COMMISSIONER REPORT

TASMAN DISTRICT COUNCIL, BROADSEA AVENUE EROSION PROTECTION STRUCTURE - APPLICATION No. RM110150 and RM110096

**Report and Decision of the Tasman District Council through
Commissioner Sharon McGarry**

Plan B
 Typical Cross Section - Broadsea Ave Rock Retement

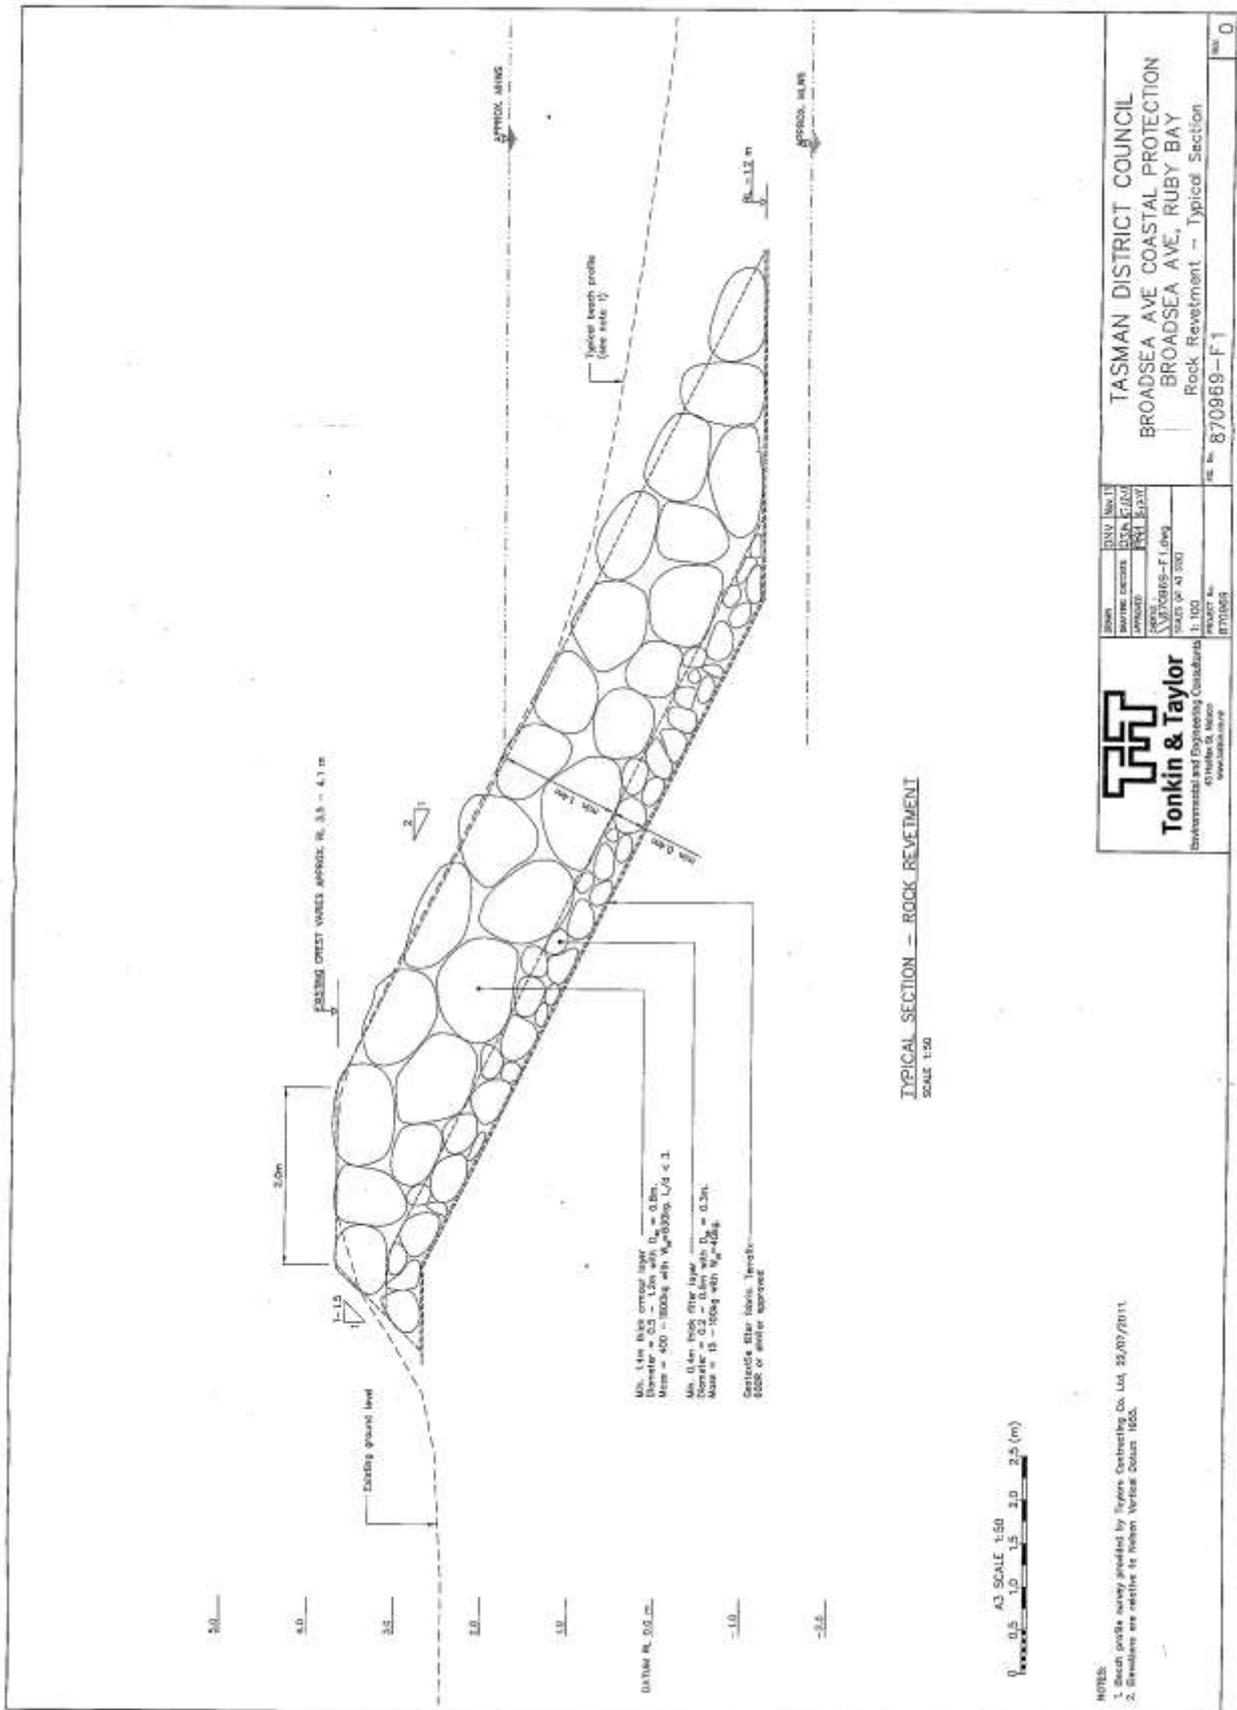
7. The Consent Holder shall at all times maintain the structure in a sound, safe and competent condition in general accordance with Plan B attached. The Consent Holder shall notify the Environment and Planning Manager of Council at the earliest opportunity after any storm event or occurrence where any part of the structure is damaged, or any situation that may result in a hazard to the public. The Consent Holder shall undertake such remedial works as may be necessary, or as directed by the Environment and Planning Manager of Council to repair and retain the revetment in a competent and safe condition.

12. The structure shall be maintained so that it has a maximum batter slope ratio of 2H:1V and in a manner that provides a relatively regular, tightly interlocking face. Any new rock material placed as part of the works shall be laid on a graded and shaped face of competent, compacted material over which is laid a geotextile cloth fabric of suitable grading. Any maintenance of the toe of the revetment (including fabric placement) shall ensure that it is embedded to a depth no higher than reduced level (RL)1.2 metres, in the manner shown on the Plan B attached to this consent. The fabric and placed rock shall extend to and terminate at or above the general level of the land immediately behind the revetment, and in such a manner as to prevent washout of sand material behind/beneath the fabric. The geotextile fabric shall be appropriately placed and anchored to ground to prevent material being lost from beneath or behind the fabric through wave action or seawater inundation. The rock material shall be placed in such a manner (e.g. on a bed of suitably graded granular material placed on the fabric) so as to prevent puncturing or tearing of the fabric.
